Access Compliance Report

Public Rights-of-Way

(Curb Ramps)

Intersection ID: 13190	Main Street: W_BLAND_ST	Cross Street: S_CHURCH_ST	Location: S
ADA ID: D2E080E4C467	Ramp Type: PerpDiag	Initial Pass/Fail: Fail	Overall Compliance: No
Severity Score: 13.75			
Codes/Mitigation Info/Possible Solution		Field Measurements/Component Compliance

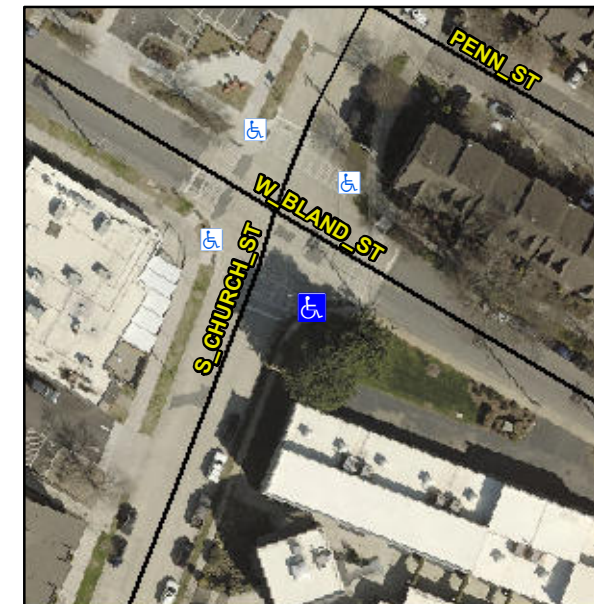
Not Found, R304.2.2, R304.5.3

Compliance	Description	Data	Compliance	Description	Data
N/A	Ramp Length (in)	95.0	No	Ramp Slope (%)	9.3
Yes	Ramp Width (in)	48.0	No	Ramp XSlope (%)	4.0
N/A	Flare Type LT	N/A	N/A	Flare Type RT	N/A
N/A	Flare Slope LT (%)	N/A	N/A	Flare Slope RT (%)	N/A
N/A	Flare Traversable LT?	N/A	N/A	Flare Traversable RT?	N/A
N/A	Landing Length (in)	N/A	N/A	DWS Provided?	N/A
N/A	Landing Width (in)	N/A	N/A	DWS Contrast?	N/A
N/A	Landing Slope (%)	N/A	N/A	DWS Length (in)	N/A
N/A	Landing X Slope (%)	N/A	N/A	DWS Full Width?	N/A
N/A	Landing Curb? (Y/N)	N/A	N/A	DWS Offset (in)	N/A
N/A	Shared Landing?	N/A			
N/A	Gutter Ponding?	N/A	N/A	Gutter Slope (%)	N/A
N/A	Gutter Lip Ht (in)	N/A	N/A	Gutter X Slope (%)	N/A
N/A	Painted X Walk1?	No	N/A	Painted X Walk2?	No
	X Walk 1 Direction	To NE		X Walk 2 Direction	To NW
N/A	X Walk 1 Width (in)	N/A	N/A	X Walk 2 Width (in)	N/A
	X Walk 1 Slope (%)	4.0		X Walk 2 Slope (%)	3.0
	X Walk 1 X Slope (%)	0.7		X Walk 2 X Slope (%)	3.5

N/A	Ramp inside XWalk1?	N/A	N/A	Ramp inside XWalk2?	N/A
	Road Slope (%)	2.3	N/A	Clear Space?	N/A
	Road X Slope (%)	2.8	N/A	Clear Space to XWalk (in)	N/A
N/A	Any Obstructions?	N/A	N/A	Storm Grate/Utility Hazard?	N/A
	Obstruction Type			Storm Grate/Utility Type	
		N/A			N/A
			Yes	Surface Condition? (G/P)	Good

Remove & Replace Curb Ramp With Two New Directional Ramps or Equivalent.
